City Council Staff Report

RE: Variance Petition VP-20-000140

PROJECT DESCRIPTION:

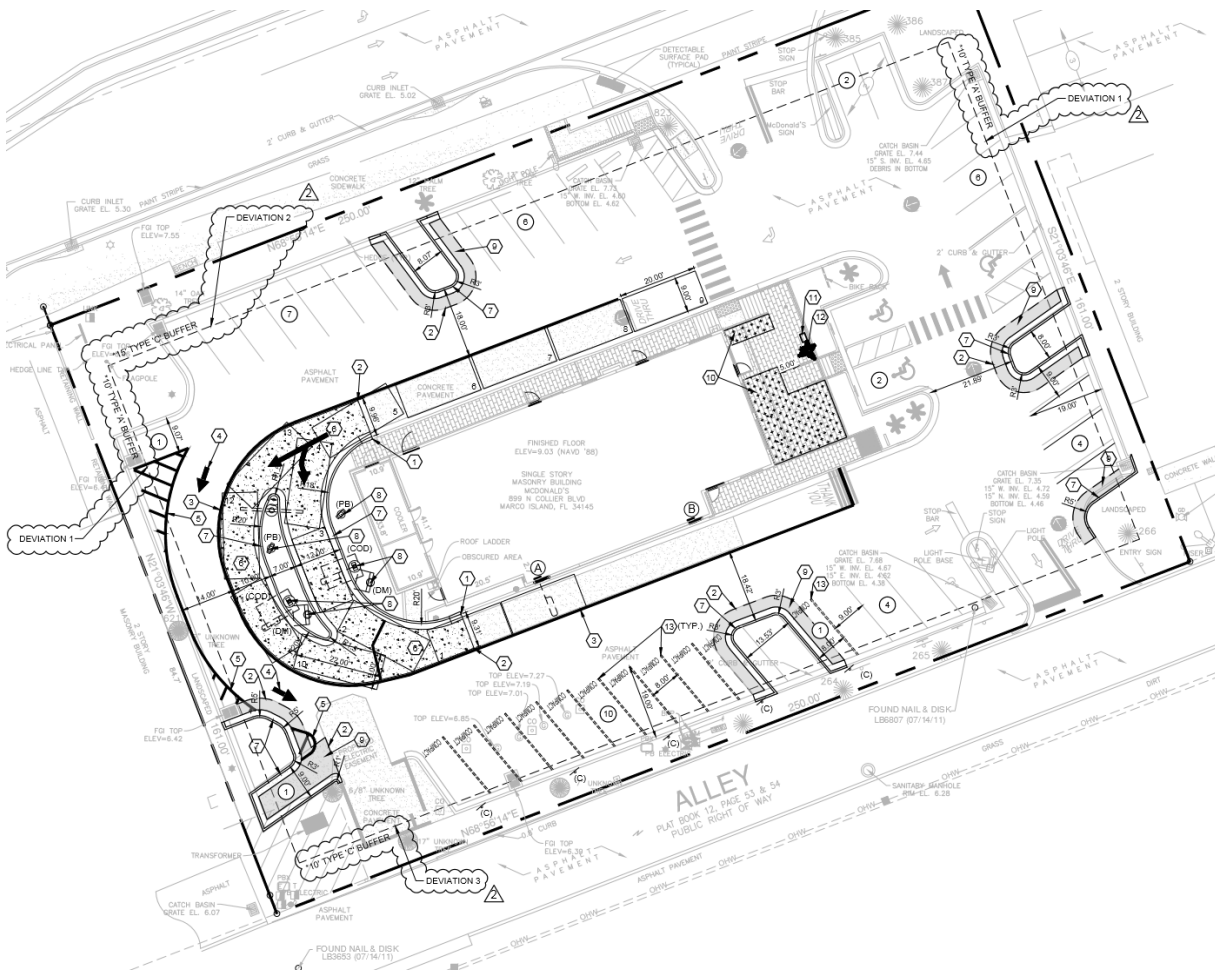
In walking the site, maintenance of the site is needed. Plant material is missing, leaving the buffers ineffective, concrete curbing is sunk and cracked, while other miscellaneous areas are in disrepair. Staff believes this plan does not go far enough for the granting a variance.

Proposed Plan

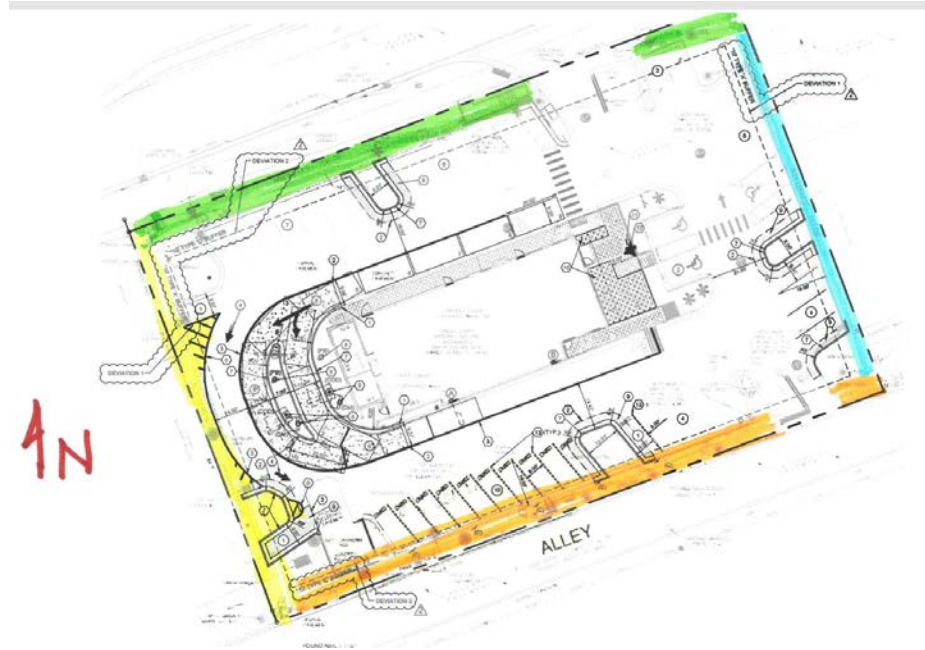
Staff is of the opinion that these minimum width buffers would be more effective if the right plant material was used, and minor changes to the plan were implemented such as:

1. Expanding the West buffer area (yellow) to include the striped area which is proposed for asphalt. This is unusable space that can be converted to landscape. These areas would also allow room for trees.

2. Revise the North buffer area hedge (green, Collier Blvd.) to be maintained at a height of 6 feet instead of 3 feet, double row. Due to the elevation of the site in relation to the road, this hedge has little impact on blocking parked vehicles or the stack-up drive thru vehicles.

3. Revise the South buffer area (orange), duplicating the North buffer along Collier Blvd.

4. Replace the concrete islands with pavers, providing aesthetics.

- (1) Variance 20-000140 plan is consistent with SDP.
- (2) Expand the west buffer area (yellow) to include the striped area which is propose for asphalt. This is unusable space that can be converted to landscape.
- (3) Revise the north buffer area hedge along Collier Blvd. to be maintained at a height of 6 feet (or 5' above the curb) instead of 3 feet, double row. Due to the elevation of the site in relation to the road, this hedge has little impact on blocking parked vehicles or the stack-up drive thru vehicles.
- (4) Revise the south buffer area (orange), duplicating the revised north buffer along Collier Blvd.
- (5) Replace the concrete islands with pavers, providing aesthetic.
